Llanmaes Flood Alleviation Scheme

Pre-Application Consultation Report
(PAC Report)

Vale of Glamorgan Council (VoGC)

8 July 2021

Figure 1: Proposed Development Plan

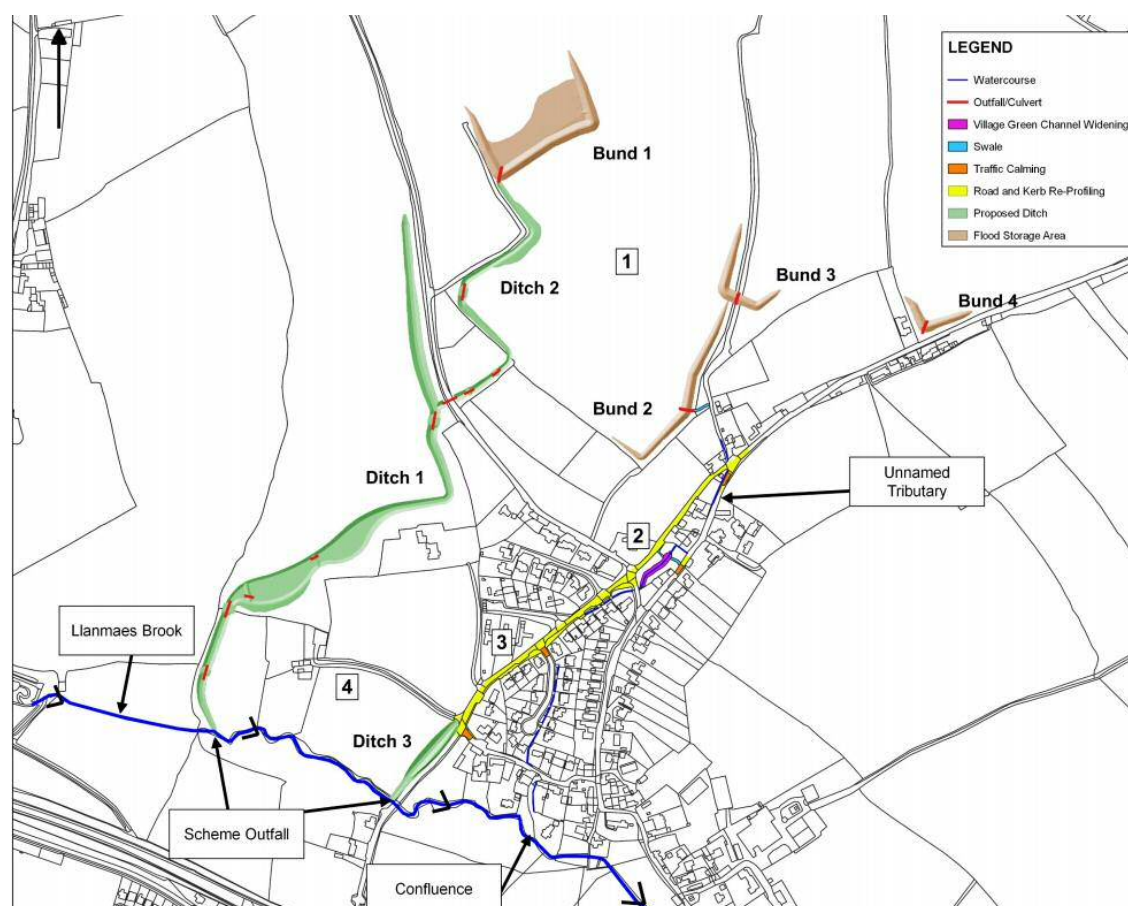
No	Comments Received	Applicants response
1	The first comment expressed concern for flood levels in the locality of a property at the south end of Llanmaes Village. Concern raised about proposed modelling not eliminating existing flood water levels at the vicinity of the south end of Llanmaes Village near the Llanmaes Brook	<p>Natural Resources Wales are the lead Risk Management Authority for fluvial flood risk associated with the Llanmaes Brook, and any concerns regarding blocked culverts or siltation of the watercourse should be raised with them directly.</p> <p>Based on the detailed modelling undertaken to develop the scheme:</p> <ul style="list-style-type: none"> - The scheme provides an overall flood risk benefit to Llanmaes however, not all flooding will be removed due to the volume of water entering the village. - At the southern end of Llanmaes, near Llanmaes Brook there is a reduction in the maximum flood depths from ~ 0.5m (present day) to ~0.3m (with scheme in place) for a large design storm event (1% AEP + 35% Climate Change). - The maximum flood depths are anticipated to be reduced to a level whereby property level protection is considered effective. - A conservative approach has been taken in the hydraulic model which assumes the surface water drainage network is full and the culvert at Pond Villa is not modelled because of this assumption. - The scheme reduces the overall volume of water entering Llanmaes and therefore reduces the burden on the surface water drainage network

2	This comment is a query on flood modelling for West Road, and how the proposed development manages the potential flood flows within West Road , near some bungalow residencies.	<p>The hydraulic model results show that the proposed scheme provides a reduction in maximum flood depths throughout Llanmaes for a range of storm events.</p> <ul style="list-style-type: none"> - The scheme provides an overall flood risk benefit to Llanmaes however, not all flooding could be removed due to the large volume of water entering the village. - At the southern end of Llanmaes, along the southern east/west road, there is a reduction in the maximum flood depths from ~ 0.4m (present day) to

No	Comments Received	Applicants response
3	This comment is a query on flood modelling for West Road, at the north of Llanmaes Village. The query relates with the use of kerbs, raised table/junctions and reprofiling the road and how the designer utilised these to manage flooding within West road and Village Green road.	<p data-bbox="1205 264 2092 325">~0.2m (with scheme in place) during a large design storm event (1% AEP + 35% Climate Change).</p> <ul style="list-style-type: none"> <li data-bbox="1205 357 2007 418">- The maximum flood depths are anticipated to be reduced to a level whereby property level protection is considered effective. <li data-bbox="1205 450 2092 572">- Upstream storage designed as part of the scheme reduces the volume of water passing down West Road and Tyle House Close across all storm events and the road table on at the West Road junction is designed to reduce overland flow passing onto the southern east/west road. <li data-bbox="1205 604 2092 687">- Through reducing the amount of water entering the unnamed watercourse that flows through Llanmaes it is anticipated that the burden on the surface water drainage network will be reduced. <p data-bbox="1205 724 2092 815">The proposed scheme is designed to reduce the volume of water entering Llanmaes during a storm event through the use of upstream storage and diversion ditches.</p> <ul style="list-style-type: none"> <li data-bbox="1205 847 2119 1066">- It is recognised that slowing the overland flow routes onto, and along, West Road may be beneficial however, it was found during the development of the scheme that reducing the overall volume of water entering Llanmaes was much more effective at reducing maximum flood levels through Llanmaes than managing the water once it had reached West Road. This is primarily because of the large volumes of water that enter the north east end of Llanmaes. <li data-bbox="1205 1098 2092 1158">- Results show that the flood storage areas provide a reduction in maximum flood depths through Llanmaes across a range of storms. <li data-bbox="1205 1190 2119 1305">- The use of road tables to manage water in West Road was weighed up between the requirements of highways management and flood risk benefits. New kerbs were introduced to reduce the volume of water escaping the West Road and thereby reducing residual risk of flooding to local properties.

No	Comments Received	Applicants response
4	<p>This comment relates with the alignment of Ditch 2 proposing an alternative to the design option.</p> <p>There concerns raised about the inconvenience for ditch 2 is causing, due to land take.</p>	<p>- Following evaluation of this option in the design stage, the existing ground levels did not allow for the alternative path for ditch 2.</p> <p>- This route would have made the scheme less efficient at removing approx. 6,000m³ of water away from Llanmaes.</p>
5	<p>This comment is an enquiry to understand further safety precautions around the attenuation storage areas.</p>	<p>- Temporary storage areas, bunds and ditches are designed to be at 1:3 and 1:5 to reduce these risks, however, the design of these assets considers that water will only be temporarily stored for the duration of the event.</p> <p>- The flood storage areas are predominantly on private land and whilst a public right of way passes along Bund 2 and Bund 3, access to the fields is prohibited.</p> <p>- Compensatory vegetation planting will be implemented as part of the scheme though the main flood risk benefits are provided by the proposed flood storage areas.</p> <p>- Where considered necessary, adequate signage warning of the dangers during a flood event and safety barriers would be implemented.</p>

6	<p>This comment was a request to meet with the designers on site to present and discuss the proposed development in more detail</p>	<p>The proposed scheme is designed to reduce the volume of water entering Llanmaes during a storm event through the use of upstream storage and diversion ditches.</p> <p>- The flood bunds will store approximately 2000 m³ in a small storm event and approximately 12,500 m³ in the most extreme storm event upstream of Llanmaes.</p> <p>- The outfall of the flood bunds will be controlled using 0.3m diameter pipe and is designed to slow the volume of water passing into the ditch to the north of the Village.</p> <p>- Erosion control has been included on all outfalls to prevent instability on slopes and it is recognised that this is particularly important at Bund 2 outfall</p>

8	<p>This comment was focused on the proposed development proposals for Village Green. The affected residence is one of the few that suffers severe flooding on major event and therefore a request for a site meeting with the designers was made.</p>	<p>The proposed scheme is designed to reduce the volume of water entering Llanmaes during a storm event through the use of upstream storage and diversion ditches. Overland flow is intercepted in the fields to the north of</p>

Enquiries raised about the design for Flood bunds 2 and 3, the West road and Village Green road and Sigingstone Lane.

- The scheme provides an overall flood risk benefit to Llanmaes however, not all flooding could be removed due to the volume of water entering the village.
- In the area around the Village Green , there is a reduction in the maximum flood depths from ~ 0.5m (present day) to ~0.3m (with scheme in place) for a large design storm event (1% AEP + 35% Climate Change).

- The maximum flood depths are anticipated to be reduced to a level whereby property level protection is considered effective.

- The location of Bund 2 has been located to provide effective upstream storage whilst also minimising the impact on the surrounding fields.

- The scheme will be maintained by VoGC to ensure the effective flood risk operation however each flood bund has an overflow pipe at a higher elevation to become activated in the event of a blockage to the low flow pipe.

- The removal of the culvert immediately upstream of the Village Green was explored in earlier stages of this project, however it was found that intercepting water in the upper catchment was the most effective way to reduce flooding in Llanmaes.

- Compensatory vegetation planting will be implemented, and plans will be provided to the Planning authority. (As discussed at site meeting 2021.05.13)

- It is recognised that overland flow from the field behind the Brook Farm development contributes to flooding in Llanmaes. Flood storage was explored in these field at earlier stages of this project and it was found that the storage volumes were relatively small compared to the other bund locations. Furthermore, to be effective the storage of water would need to be in close proximity (<30m) to the residential properties. It was agreed with VoGC that this did not present a practical solution and the more effective upstream storage locations were taken forward.
